Service Note		
Products	Description:	Service note no.
Nova pedals: Delay, Reverb, Modulator, Repeater	Start up problems w. AC adaptor	SNo-T0159

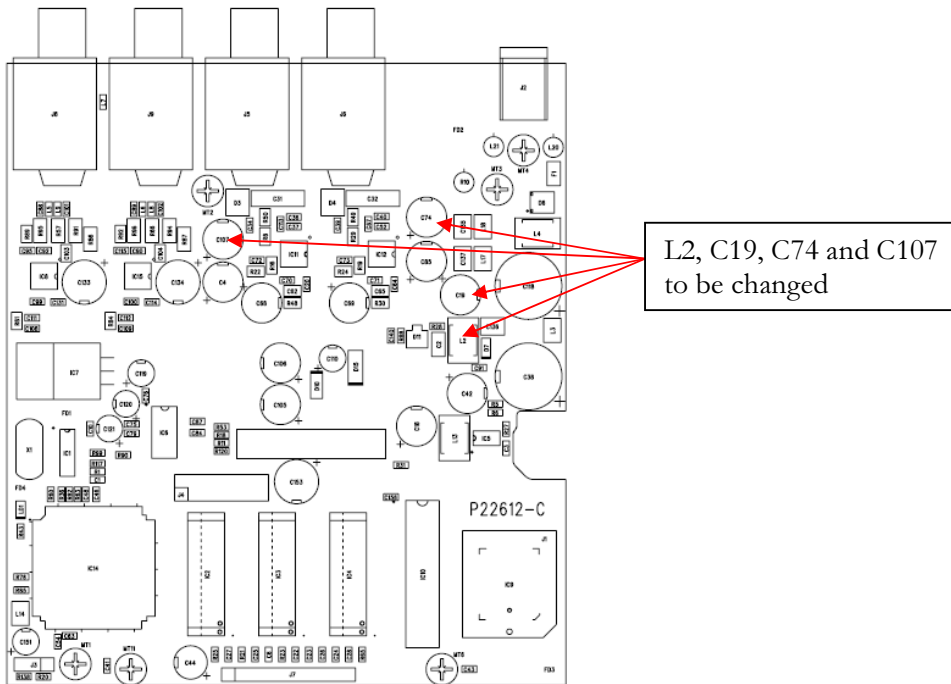
We have encountered a problem on a few of the Nova pedals mentioned. The -12V DCDC doesn't start up correctly and forces the 400mA AC adaptor to go into protection mode. The EUT blinks in the LED's but doesn't get up running.

C19, C74, C107 must be changed from 100uF to 47uF, 25V

L2 must be changed from 150uH to 33uH (TC stock no: 7E50201301)

Our tests show that the Nova pedals by this change can handle incoming supplies from 8.5V.
